Appl. No. 09/854,362  
Amdt. Dated March 18, 2004

Annotated Sheet Showing Changes

**FIG. 1a**

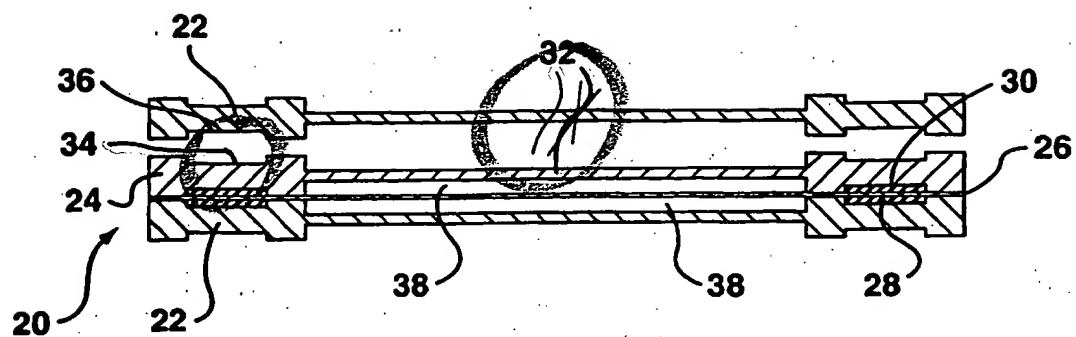
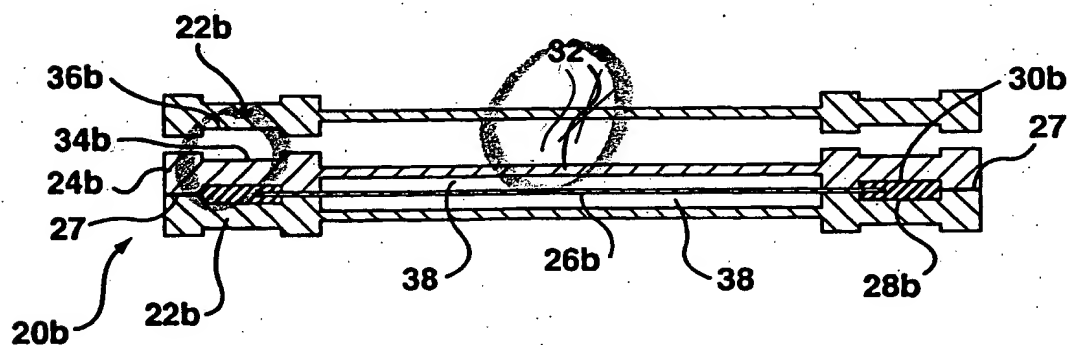
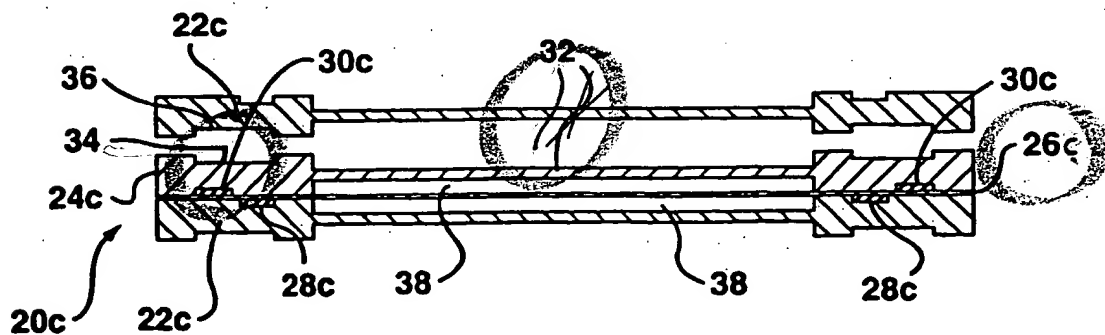
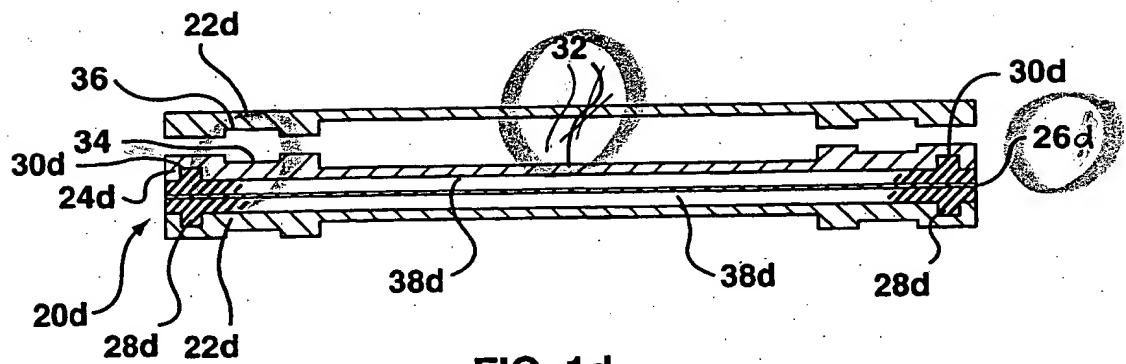
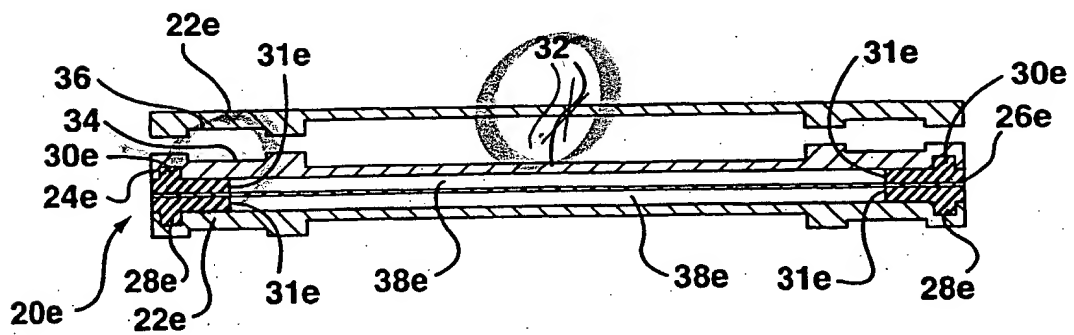
With respect to the drawings, it will be understood that the amendments to the

lead lines in Figures 1 and 2 are intended merely to ensure that these drawings are wholly consistent with the specification and to aid in understanding the drawings.
